Product/Process Change Notice (PCN)	
<input checked="" type="checkbox"/> Major Change <input type="checkbox"/> Minor Change	
PCN Number: PCN_WIRL-LORA_20250313 Affected Series: WIRL-LORA, WIRL-EVAL Affected Part Number: 2618011181000, 2618019381001 PCN Date: 2024-12-13 (YYYY-MM-DD) Effective Date: 2025-03-13 (YYYY-MM-DD)	Change Category: <input type="checkbox"/> Equipment/Location <input checked="" type="checkbox"/> General Data <input type="checkbox"/> Material <input type="checkbox"/> Process <input type="checkbox"/> Product Design <input type="checkbox"/> Shipping/Packaging <input type="checkbox"/> Supplier <input checked="" type="checkbox"/> Software
Contact: Product Management Phone: +49 (0) 7942 - 945 5001 Fax: +49 (0) 7942 - 945 5179 E-Mail: pcn.eisos@we-online.com	Datasheet Change: <input checked="" type="checkbox"/> Yes <input type="checkbox"/> No Attachment: <input type="checkbox"/> Yes <input checked="" type="checkbox"/> No

DETAILS OF CHANGE:

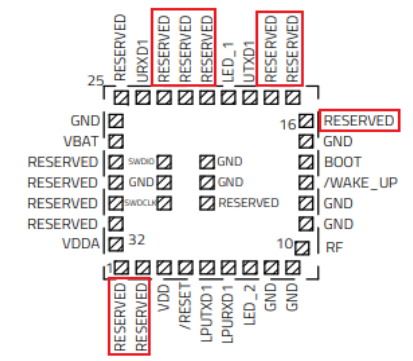
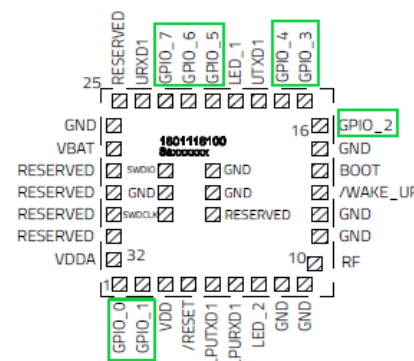
DESCRIPTION OF CHANGE: <p>In order to enhance the product functionality, Würth Elektronik eiSos will include new feature in its Daphnis-I module firmware.</p> <p>There will be no change in form, fit, quality or reliability of the product.</p> <p>The new firmware revision has no impact on the CE declaration of conformity.</p> <p>Refer to the "DETAILS OF CHANGE" section for more information on the changes in the firmware version 1.4.0.</p> <p>The new revision of the affected part numbers will be sent out after the previous revision is out of stock (according to FIFO - first-in, first-out).</p> <p>Würth Elektronik eiSos recommends its customers to update the firmware version of existing modules to version 1.4.0.</p> <p>The installed firmware version can be recalled from the last three digits of the lot number.</p> <p>For customer testing purposes, Würth Elektronik eiSos will provide the firmware images and the updated version of the user manual one month in advance, i.e. 2025-02-13. Contact wcs@we-online.com to request for the latest firmware update package.</p> <p>In case a firmware freeze to the current version is required, contact your local sales person or our support team at wcs@we-online.com</p>

Before PCN	After PCN
Product pinning		
Product label		
Interface1 Bitrate	115.2 kbps	9.6 kbps
Supply Current Transmitting	24.5 mA	26.5 mA
